LSC Responses to TIS Redline Comments

Waterbury Filing Nos. 1 and 2 Traffic Impact Analysis (LSC #204220) March 11, 2022

Waterbury Roundabout (LSC #204220)

Figure 1 Conceptual 120' ICD Roundabout Parameters

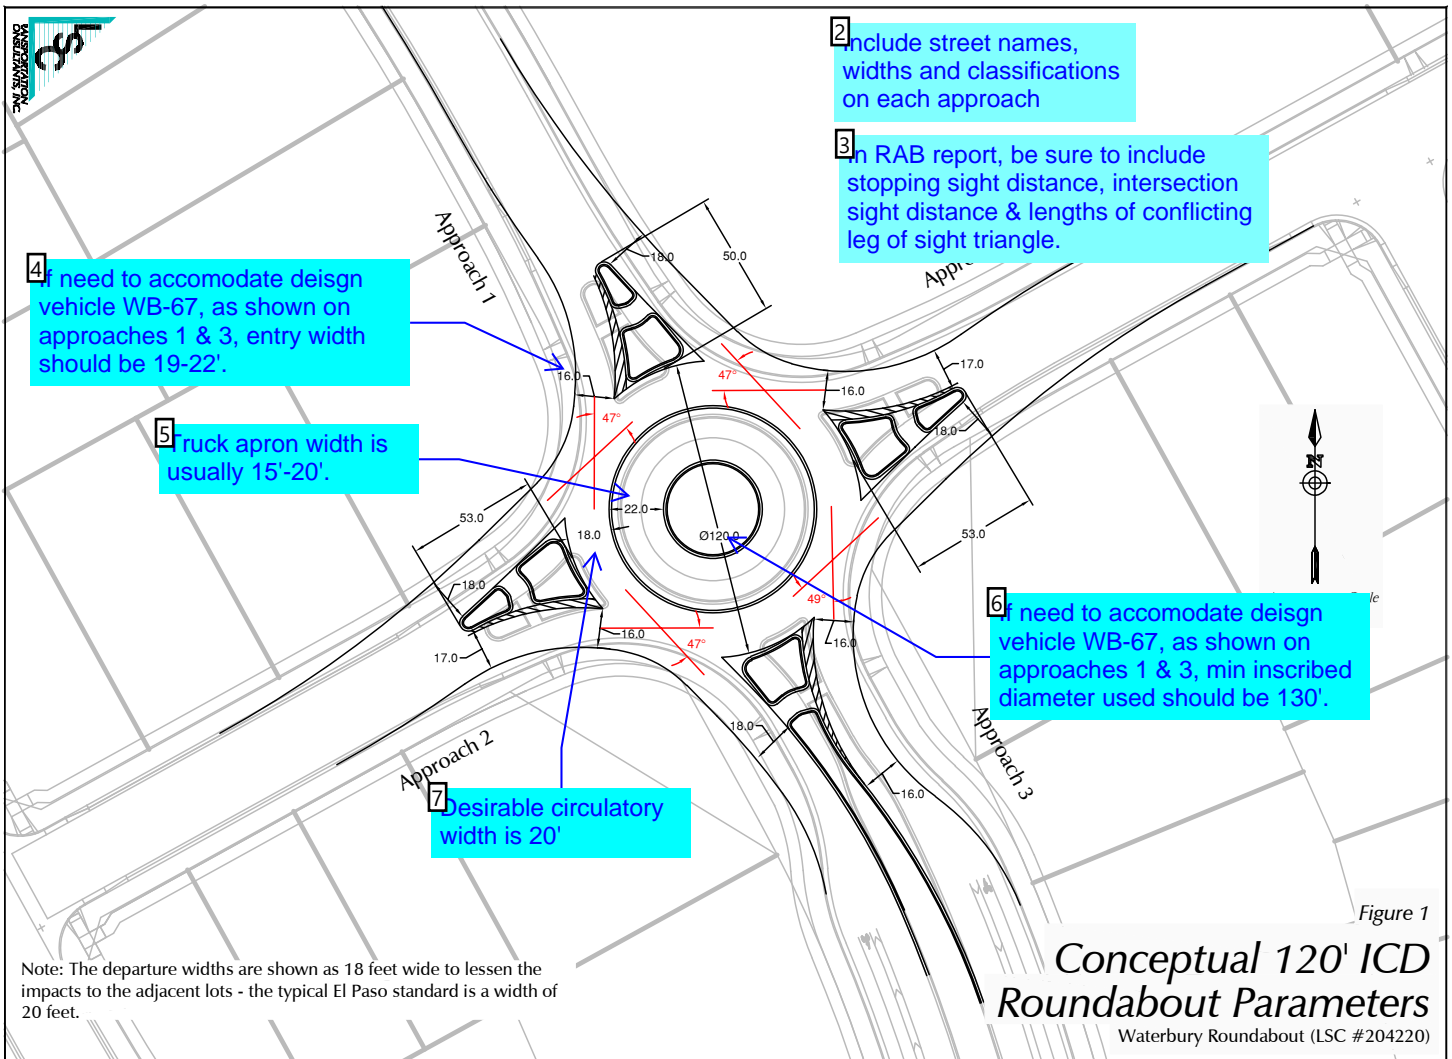
Provide exhibits on updated lot and street layout

Include street names, widths and classifications on each approach

In RAB report, be sure to include stopping sight distance, intersection sight distance & lengths of conflicting leg of sight triangle.

If need to accomodate deisgn vehicle WB-67, as shown on approaches 1 & 3, entry width should be 19-22'.

Truck apron width is usually 15'-20'.

If need to accomodate deisgn vehicle WB-67, as shown on approaches 1 & 3, min inscribed diameter used should be 130'.

Desirable circulatory width is 20'

LSC Response: The base has been revised. The prior roundabout design linework has been removed.

LSC Response: Added as requested.

LSC Response: These will all be included in the design report. The complete design report will be included with the CD set. The intent of this exhibit at this Preliminary/PUD stage of the process is to show that the roundabout and approach legs will work with the lot and street layout.

LSC Response: Per the 6/23 meeting with staff, LSC has added the flowline dimensions in addition to the 16.0' dimensions to reflect use of the hatched area by trucks. As shown, these added dimensions are consistent with the 19-22' shown in the comment.

The hatched area is needed to accommodate the larger trucks, without increasing the speed of passenger vehicles, and striping/pavement markings are typically used. However, as with other roundabouts in EPC, concrete or different colored pavement should be used for this hatched area in lieu of pavement markings and should be designed flush with the asphalt. The purpose is to eliminate the need to maintain hatch pavement markings.

LSC Response: As discussed, the 15'-20' is acceptable provided the remaining center island can be landscaped sufficiently to limit lines of sight across/through the roundabout. The large apron is primarily needed to accommodate a WB-67 U-turn. A U-turn by a WB-67 is very unlikely; however, as shown in the truck-turning figures, a 270-degree turn is shown for a WB-67 instead of a direct right-turning movement. The larger truck apron is needed for a 270-degree "right-turn" movement.

Two concepts for design were discussed.

- 1) Use concrete for the outer portion of the truck apron most likely to be used, but use landscape blocks or colored concrete for the inner portion that may see very infrequent use by a turning WB-67.
- 2) If necessary to limit line of sight across the center circle, potentially bushes or easily-replaced vegetation could be used that may (very infrequently) be driven over by the rear wheels of a WB-67.

LSC Response: At the 6/23 meeting with staff, we discussed that the more compact 120' diameter has been used to allow for a roundabout without major impacts to the street/lot layout. The WB-67 truck-turning exhibits show the accommodation of the occasional WB-67 truck, including the larger truck apron as discussed in the above comment response.

Figure 1
Conceptual 120' ICD Roundabout Parameters
Waterbury Roundabout (LSC #204220)

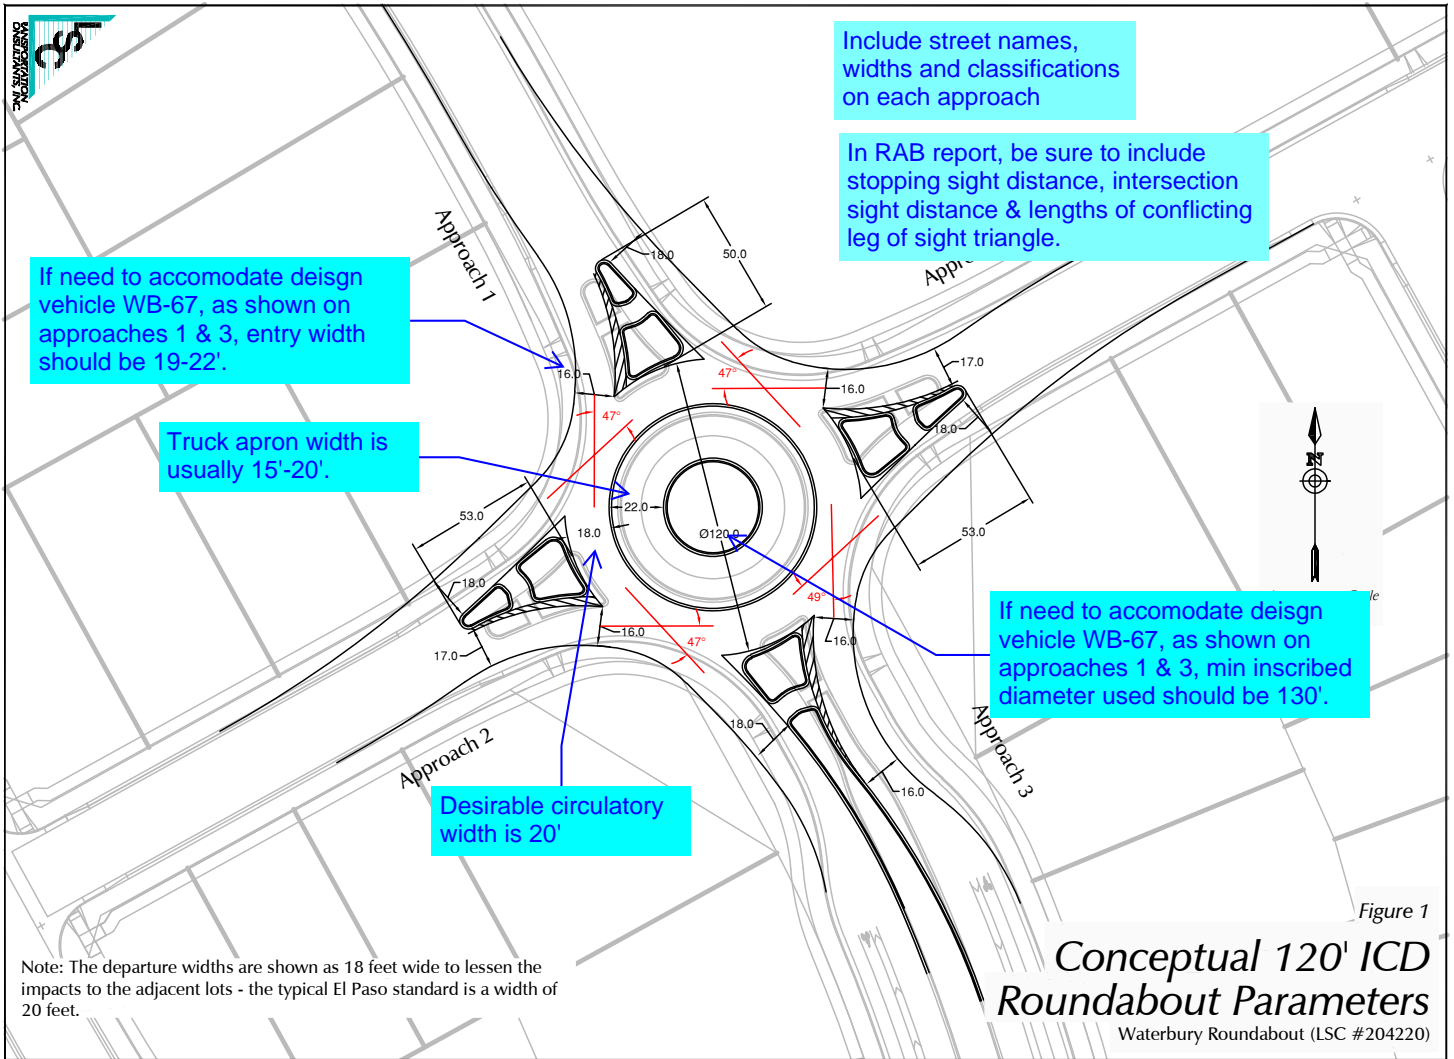
Provide exhibits on updated lot and street layout

Include street names, widths and classifications on each approach

In RAB report, be sure to include stopping sight distance, intersection sight distance & lengths of conflicting leg of sight triangle.

If need to accommodate design vehicle WB-67, as shown on approaches 1 & 3, entry width should be 19'-22'.

Truck apron width is usually 15'-20'.

Desirable circulatory width is 20'

If need to accommodate design vehicle WB-67, as shown on approaches 1 & 3, min inscribed diameter used should be 130'.

LSC Response: Discussed the need for a more compact design. LSC will add the flowline dimension to the splitter island in addition to the 18' dimension.
